**City of Kingston**  
**Report to Heritage Properties Committee**  
**Report Number HP-24-012**

**To:** Chair and Members of the Heritage Properties Committee  
**From:** Jennifer Campbell, Commissioner, Community Services  
**Resource Staff:** Kevin Gibbs, Director, Heritage Services  
**Date of Meeting:** February 21, 2024  
**Subject:** Application for Heritage Permit  
**Address:** 47 Wellington Street (P18-386)  
**File Number:** File Number: P18-096-2023

An application for alteration under Section 42 of the *Ontario Heritage Act* (P18-096-2023) has been submitted to support a total of 17 condominium units for the entire property by building a rear yard, four-storey flat-roofed addition with an associated service elevator that will attach to the existing schoolhouse. This application was deemed complete on January 4, 2024. The *Ontario Heritage Act* provides a maximum of 90 days for Council to render a decision on an application to alter a heritage building under Section 42(4). This timeframe will expire on April 3, 2024.

**City File**

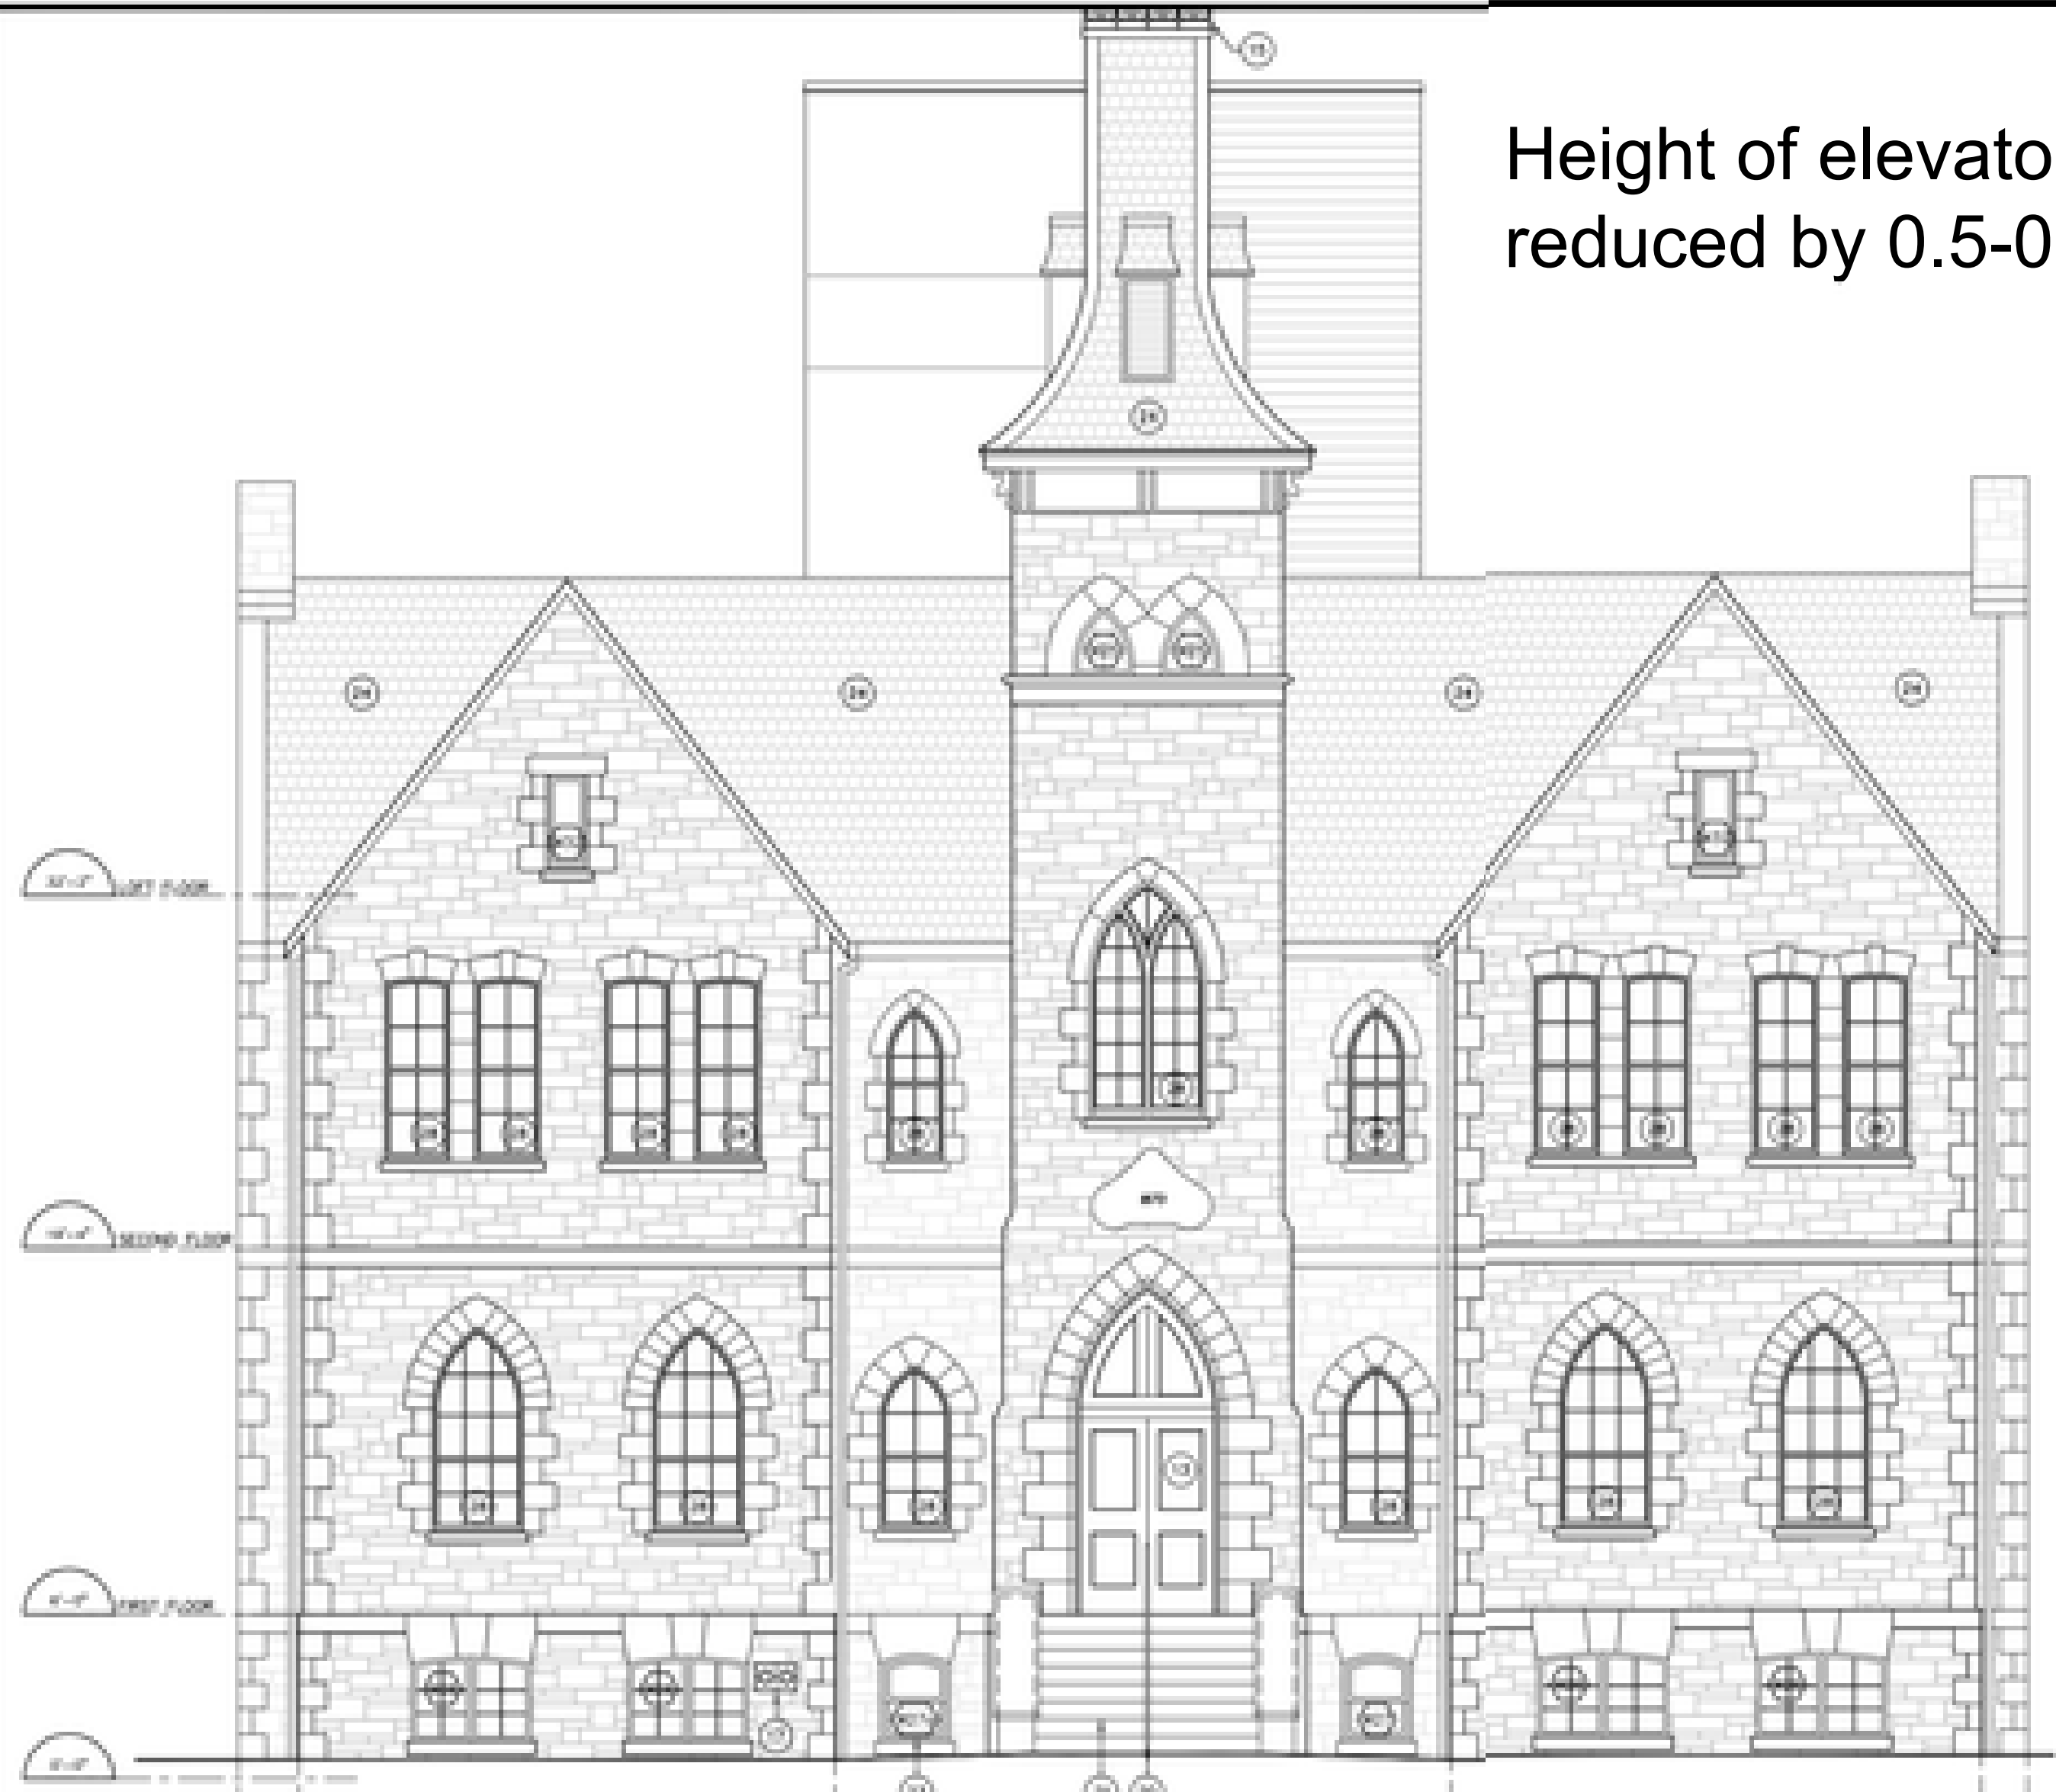
Height of elevator overrun reduced by 0.5-0.75 metres

PROJECT	DATE
17077_APP_01.DWG	2023-11-27
PROJECT #	
17077	
SHEET #	A201

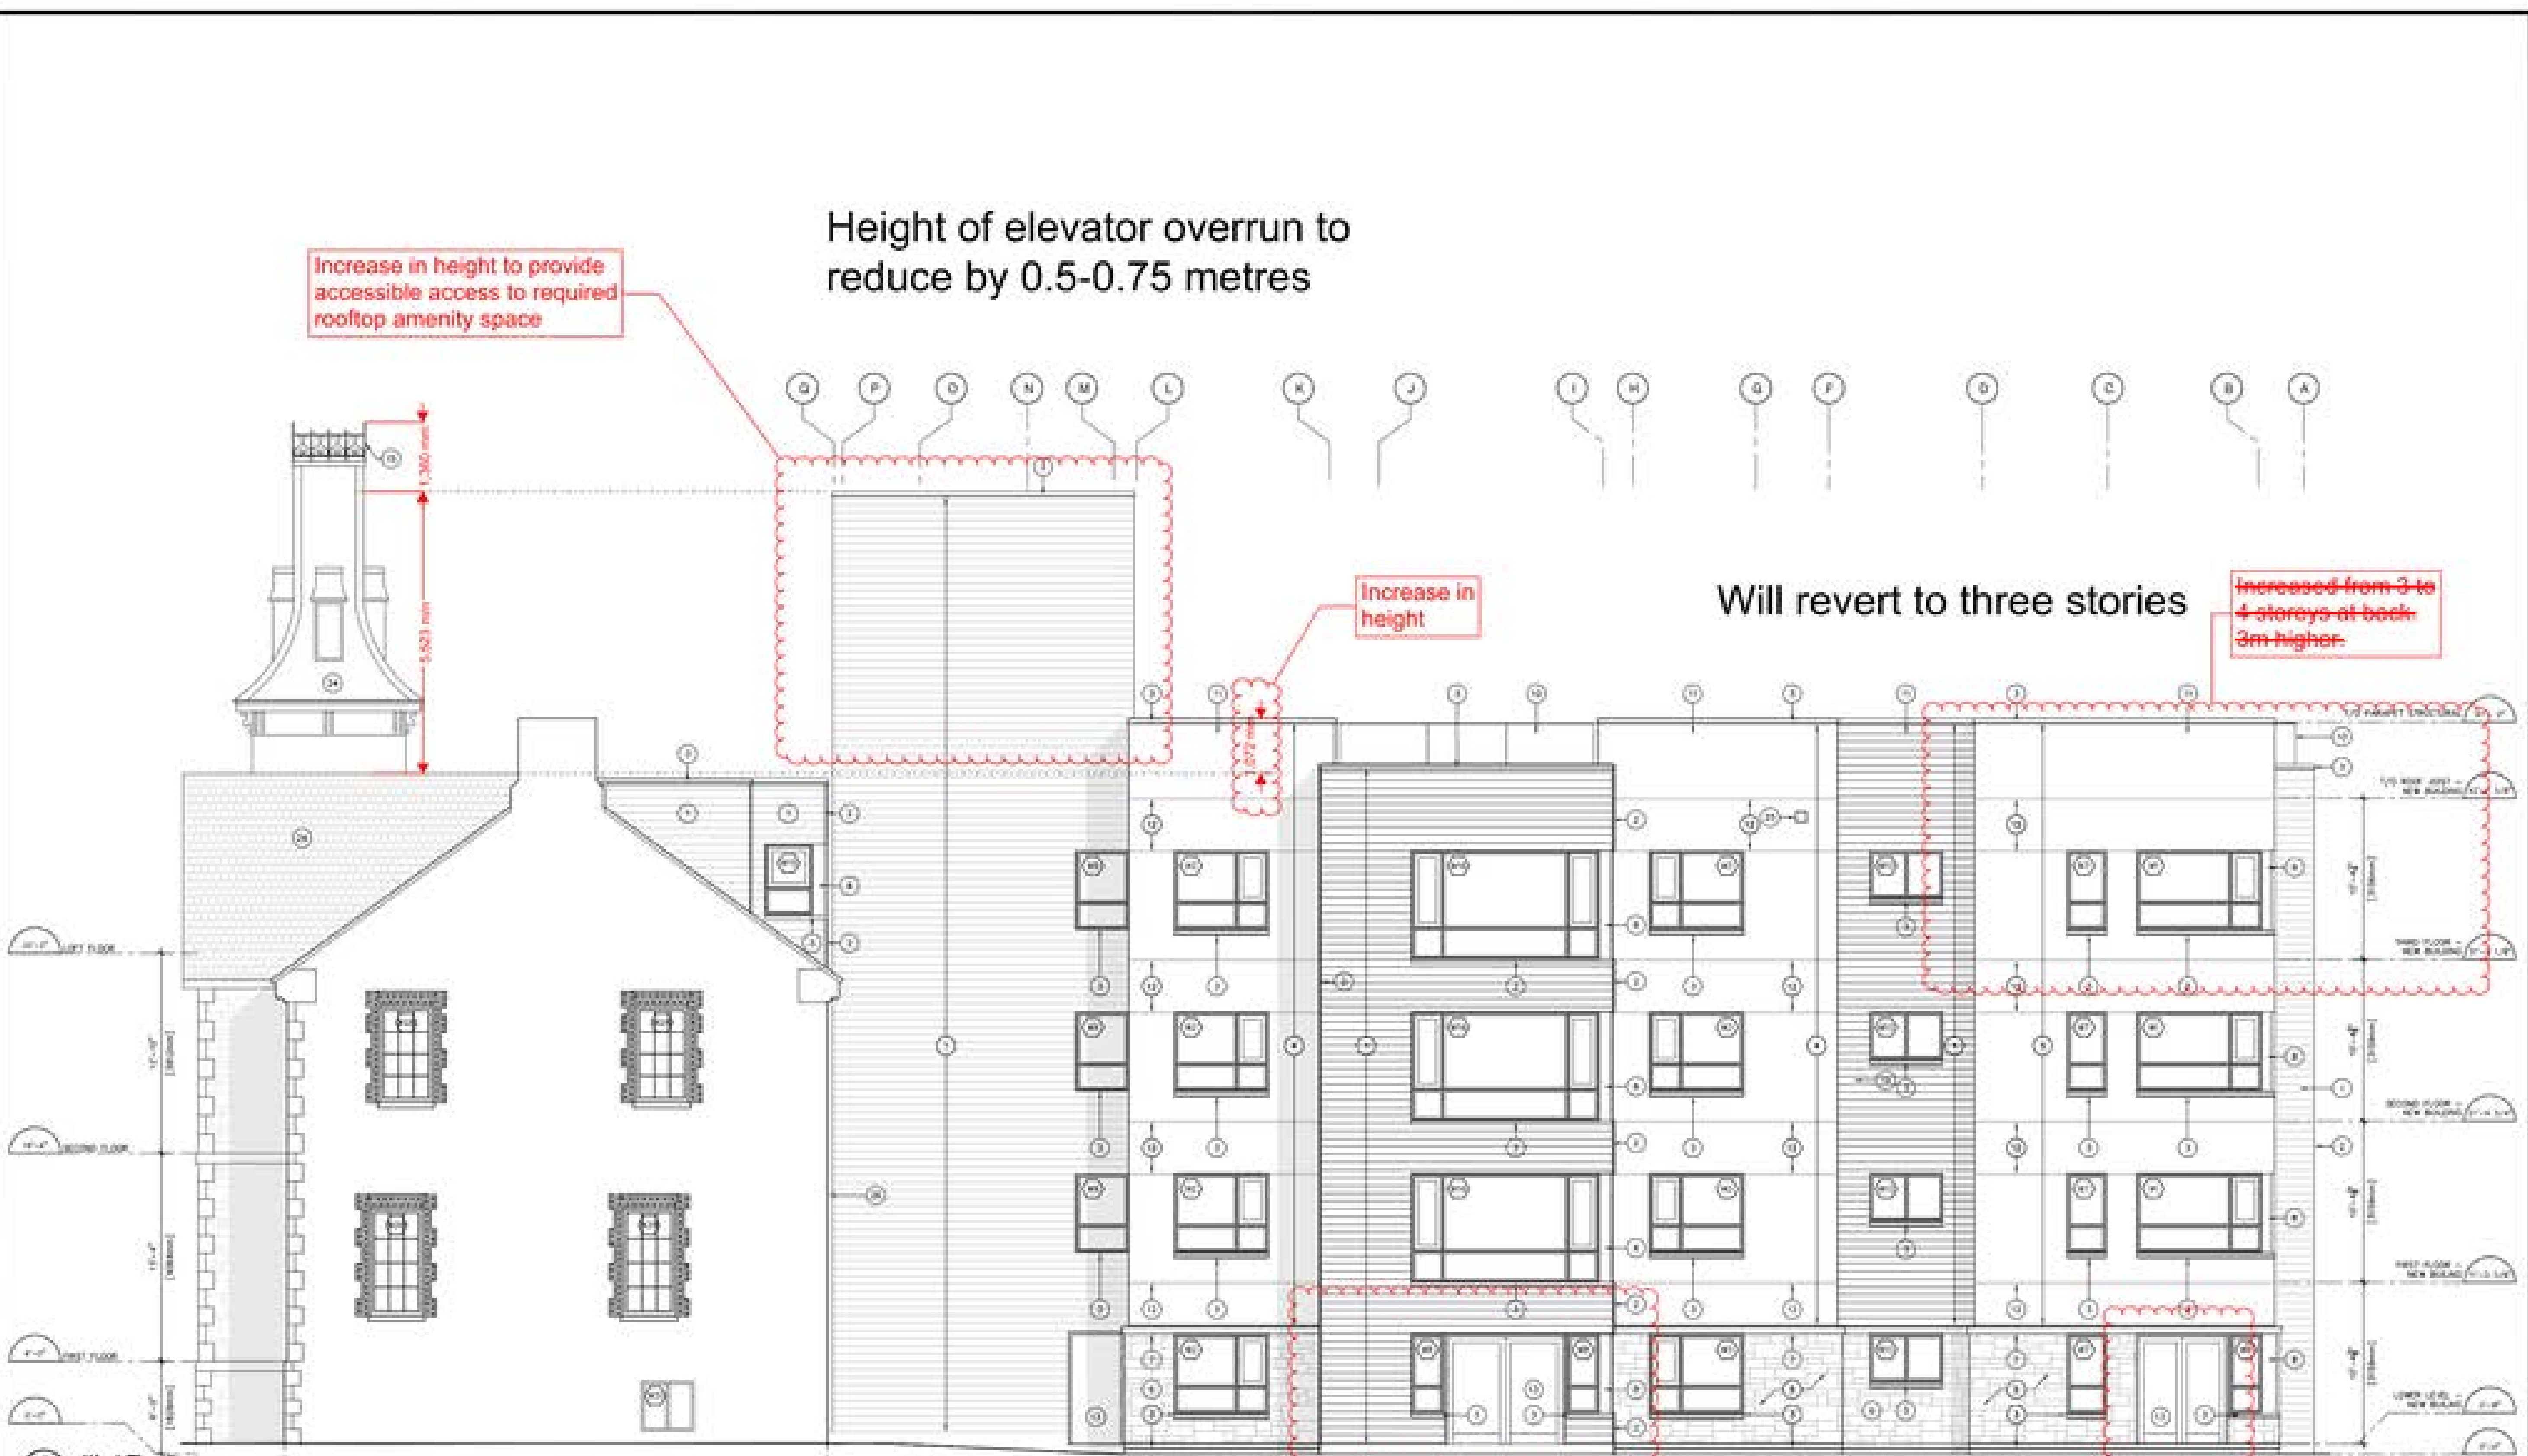
Height of elevator overrun to reduce by 0.5-0.75 metres

Increase in height to provide accessible access to required rooftop amenity space

Increase in height

Will revert to three stories

Door added

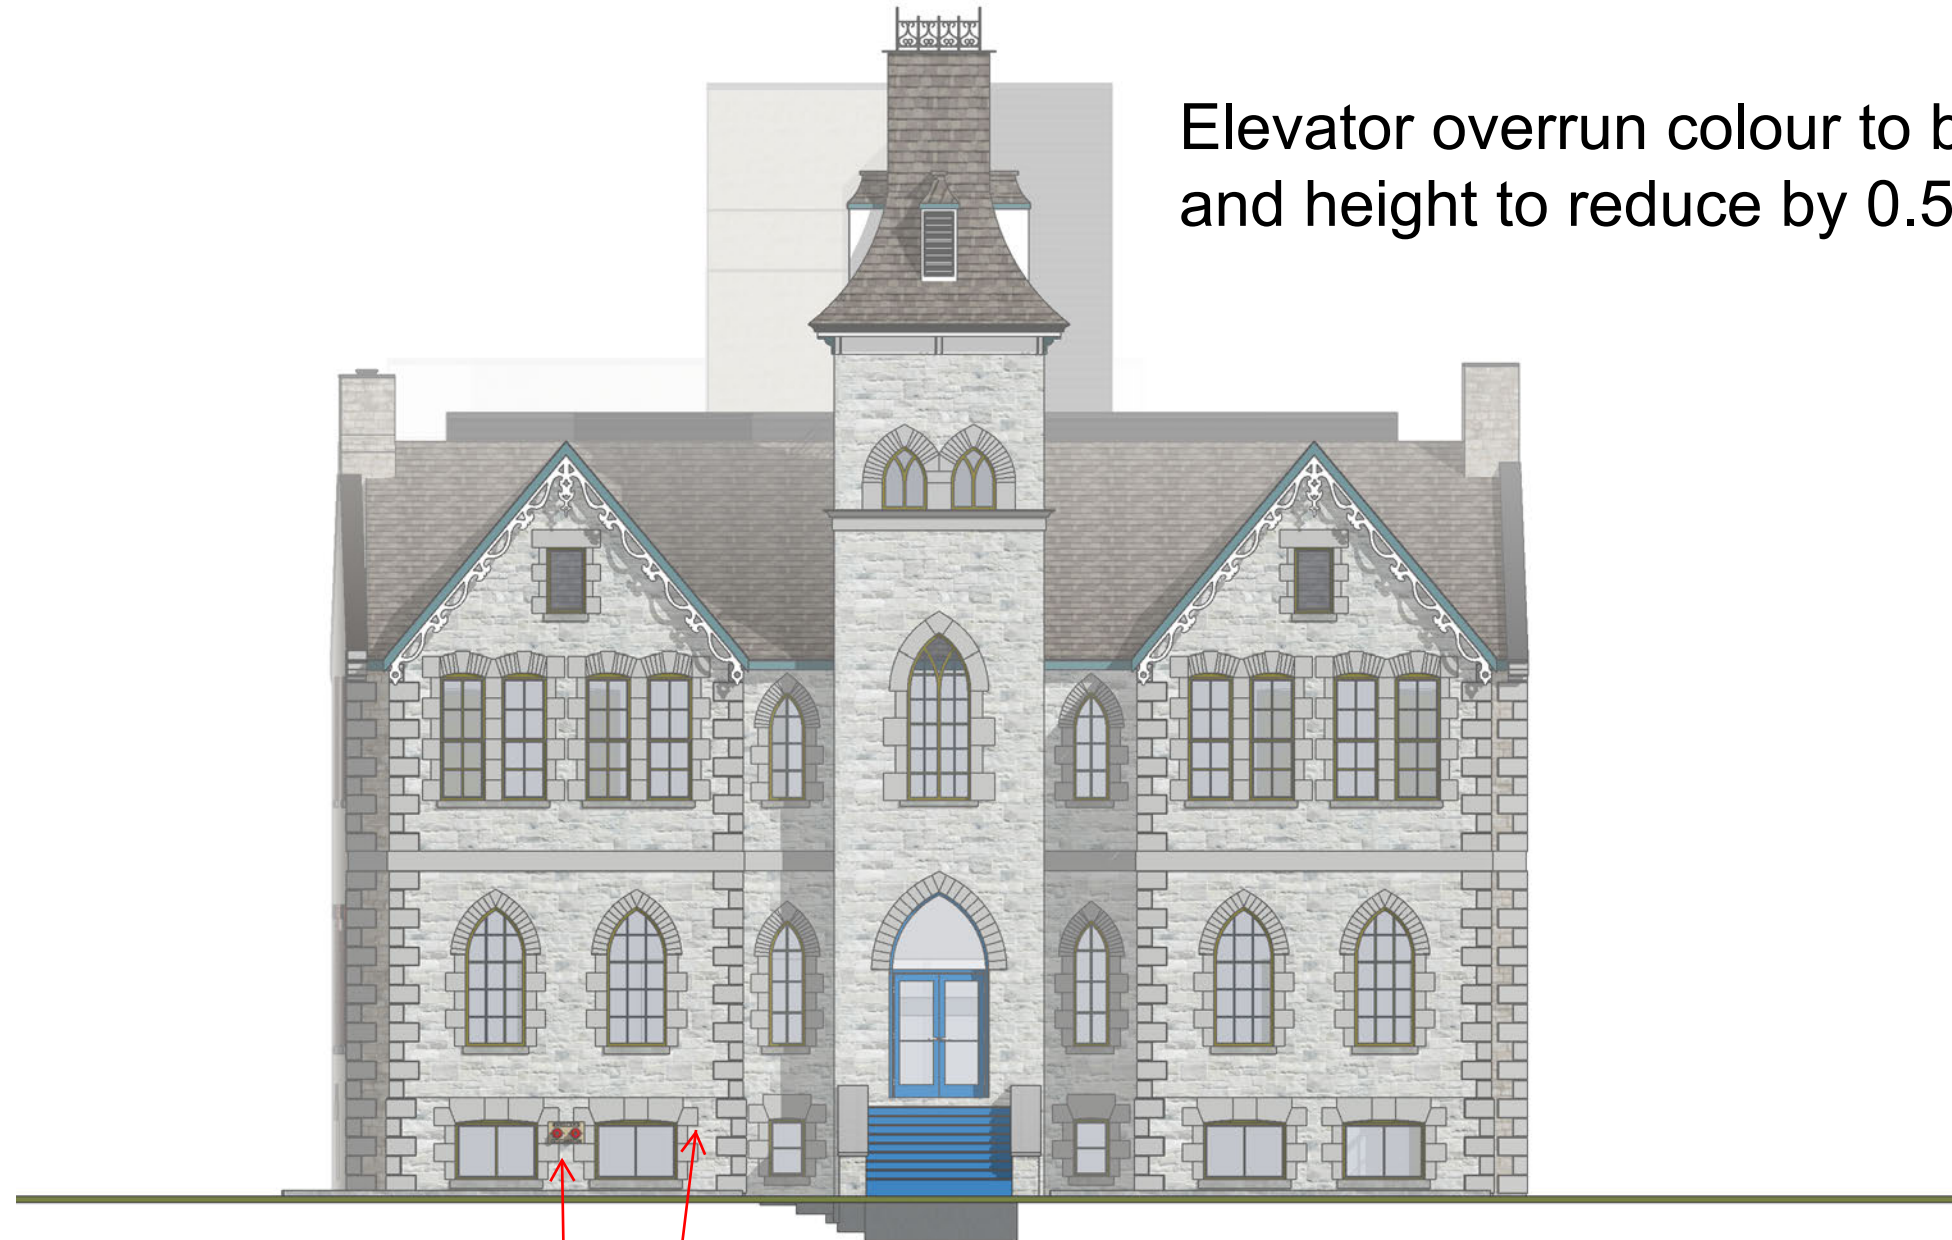
Elevator overrun colour to be more muted  
and height to reduce by 0.5-0.75 metres

Firehouse outlet to  
be moved to the  
second red arrow.

Elevator overrun colour to be more muted  
and height to reduce by 0.5-0.75 metres
